CITY OF
PALO ALTO

Expanded Community Advisory Panel (XCAP)

THIS PACKET INCLUDES:

A compilation of emails (public comments, etc) submitted to the XCAP email box, XCAP@CityofPaloAlto.org, between **November 18 and December 2, 2020 at 12:00 pm approximately**.

Why Kingsley to Embarcadero?

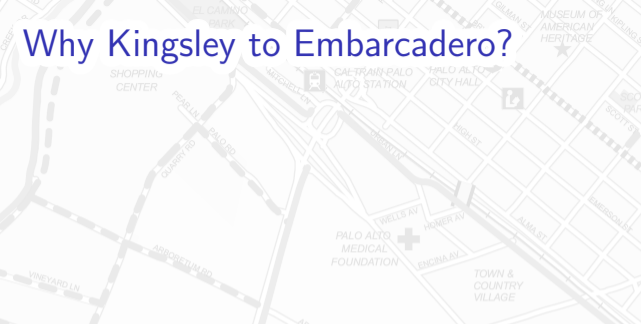
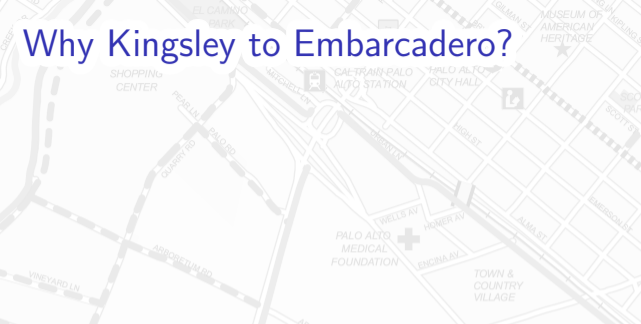
Directness: riding on the sidewalk, the current infrastructure provides an indirect route with sharp corners at both High St and Emerson St.
